Docket Item #9
Development Site Plan #2009-0009
5000 Polk Avenue – James K. Polk Elementary School

Application	General Data	
Project Name: James K. Polk Elementary School	PC Hearing:	October 6, 2009
	If approved, DSP Expiration:	October 6, 2012 (36 months)
	Plan Acreage:	Site: 587,803 SF (13.49 acres)
Location: 5000 Polk Avenue	Zone:	R-12 and R-20
	Proposed Use:	School Gymnasium Addition
	Gross Floor Area:	Existing: 61,474 SF Proposed: 6,875 SF Total: 68,349 SF
Applicant: Alexandria City Public Schools	Small Area Plan:	Seminary Hill
	Historic District:	N/A
	Green Building:	Project will seek LEED Silver Certification but, at a minimum, will attain LEED Certification

Purpose of Application
 Development site plan to replace outdated mechanical and electrical systems with energy efficient systems, construct a gymnasium addition to meet Virginia State education standards and construct a surface parking lot.

Figure 3: Partial South Elevation - Proposed Gymnasium, Mechanical Room and Solar Panels

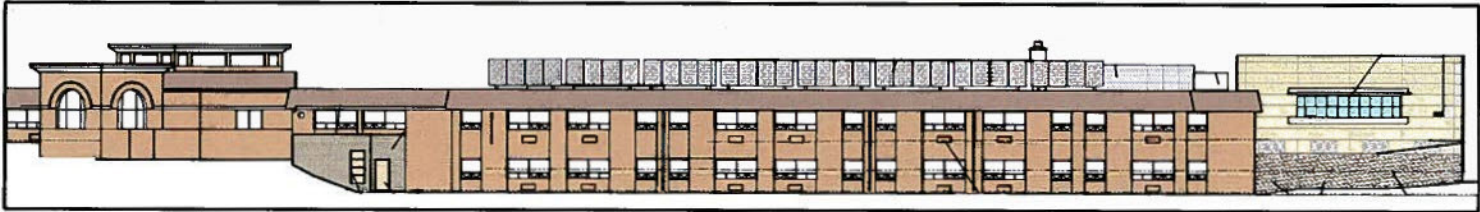
ACPS also proposes to construct a 635 square-foot mechanical room addition. The mechanical room addition is proposed along the southern side of the building and is designed with exterior brick to match the existing school. The room is approximately 12 feet in height and is designed to accommodate a hot water storage tank and other mechanical system upgrades, including pumps for a geothermal energy system.

ACPS also proposes to install south-facing solar photovoltaic panels on the roof of the existing school, between the main school entrance and the proposed gymnasium. As proposed, the photovoltaic panels are attached to the existing roof with galvanized metal supports and are largely screened from Polk Avenue by the existing roof line of the multi-purpose room. The photovoltaic panels are designed to convert solar energy into electricity and contribute to on-site renewable energy credits for the Leadership in Energy and Environmental Design.
